**Proposed Milton Quarry East Extension**  
**JART COMMENT SUMMARY TABLE – Ecological Enhancement Plan**

JART Comments (December 2022)	Reference	Source of Comment	Applicant Response (January 2023)	JART Response (June 2023)
<b>Report/Date: Ecological Enhancement Plan (EEP) &amp; Rehabilitation Plan Report December 2021</b> <b>Author: Goodban Ecological Consulting Inc.</b>

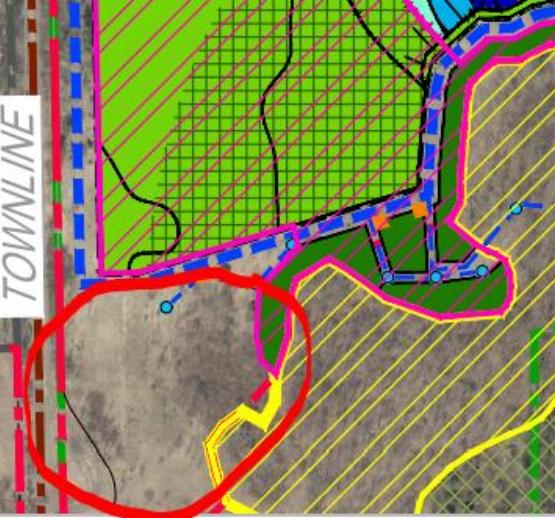
JART Comments (December 2022)	Reference	Source of Comment	Applicant Response (January 2023)	JART Response (June 2023)
6.	<p>Figure 8. Combined Ecological Enhancement Plan (EEP) and MQEE Rehabilitation Plan: Regarding the CUM1-1c vegetation community (ELC unit, circled in red in figure below) located within the Southwest corner, given the lag time of potential future uses, CH recommends the opportunity for reforestation enhancement and the improvement of that quality and function of habitat.</p>  <p>NEC would also support seeing enhanced reforestation efforts in this area, in order to improve any remaining east-west linkages to the Cox Tract given removal of Woodland A. This would address the NEP objectives and policies respecting enhancing natural heritage features and functions.</p>	<p>Ecological Enhancement Plan and Rehabilitation Plan Report</p>	<p>CH NEC</p>	<p>The EEP has been designed to provide net ecological enhancement for key natural heritage features proposed to be removed. Overall, the EEP provides a significant enhancement in overall forest cover compared to existing conditions and reforestation of this area was not deemed necessary to meet the policy requirements of the NEP. Furthermore, this area is part of the lands proposed to be conveyed to Conservation Halton and this area in the future could serve as a strategic area for a small parking area, trailhead etc.</p>	<p>On January 1, 2023, Ontario Regulation 596/22 came into effect. As a result, technical review services for planning and development applications previously provided by Conservation Halton (CH) under Memorandums of Understanding with municipalities (e.g., technical reviews related to natural heritage and select aspects of stormwater management) can no longer be provided. However, to facilitate the transition of our review to other JART members, CH has reviewed the response and based on the meeting held on January 24, 2023, CH can confirm that this comment has been addressed.</p>
